Persimmon Homes Planning Application 2020/0962

The comments below are the views, comments and objections expressed by Easton Parish Council in respect of the Planning Application (June 2020) presented by Persimmon Homes in planning application 2020/0962.

Easton Parish Council is unable to support this application as it fails to comply with several planning policies. We would ask that this application is **Deferred** permission until the matters listed have been addressed.

Formal Play areas

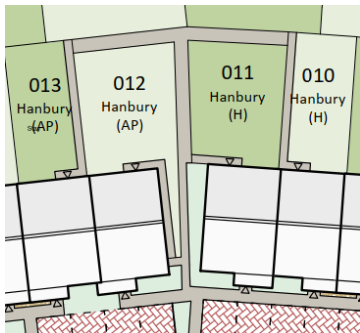
The Parish Council raises concerns to the positioning of visitor spaces next to LAP’s and would look for clarification on this matter given it was opposed on safety grounds concerning planning application 2019/1251. We note that the Police have also raised concerns within their additional comments dated 2nd July 2020.

It should be noted that the Parish Council will only adopt children’s play areas in which we have been involved in the design and our preferred supplier is used. The reason behind this is to ensure a single contractor can service and maintain all the play areas which provide a major cost saving to the parish. Our preferred supplier is a local company called Action Play and Leisure.
